29 Road Interchange at I-70, NEPA/1601 Project

Meeting Name: TAC Meeting #15

Meeting Date: June 24, 2025

Westbound I-70 Model Results (AM Peak)

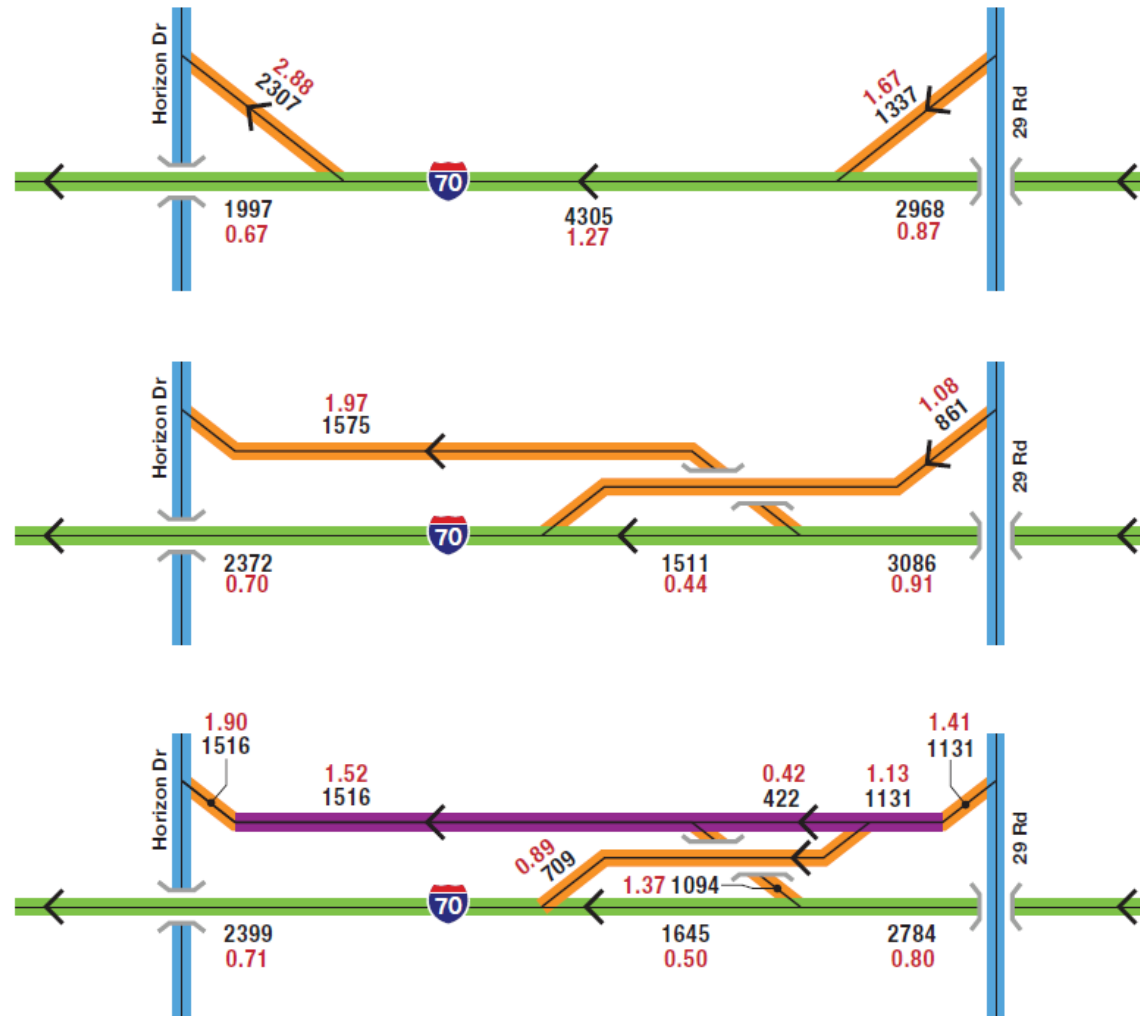
- ▶ **Question:** Regarding changing the ramp to an “Expressway” is that exclusive to or limited to the change that you made in the model or is that also a change that was made in the highway capacity analysis software?

- ▶ **Statement:** In other words, you're matching the Expressway link type that was coded into the RTPM model, correct?

Question: In reviewing the graphics, is there a connection from 29 Road to Horizon Drive for the braided ramps?

Question: There is a 1.37 VC ratio for the off ramp and a volume of 8,219 vehicles for the C-D road option. Additionally, it was mentioned that traffic from 29 Road cannot exit here and they would need to take a different route. What is the projected traffic volume for the No Action Alternative scenario? Is it similar to the 8,219 vehicles or much higher or lower?

Response: This is all strictly with respect to the travel demand modeling work that we completed. We did not make any changes in the traffic operations analysis.

Response: That is correct, we're using the Expressway link type to represent a collector-distributor (C-D) road or a braided ramp scenario (see exhibits below).

Response: No. With the braided ramp scenario (without the slip lane), a driver cannot use I-70 to travel from the 29 Road interchange to the Horizon Drive interchange. A driver would need to use Patterson Road or F½ Road.

Response: We do not have those numbers available at this time; however, we can submit them for review. I seem to recall that the No Action Alternative ramp volume here is similarly high as there is a lot of demand for the airport and for Horizon Drive.
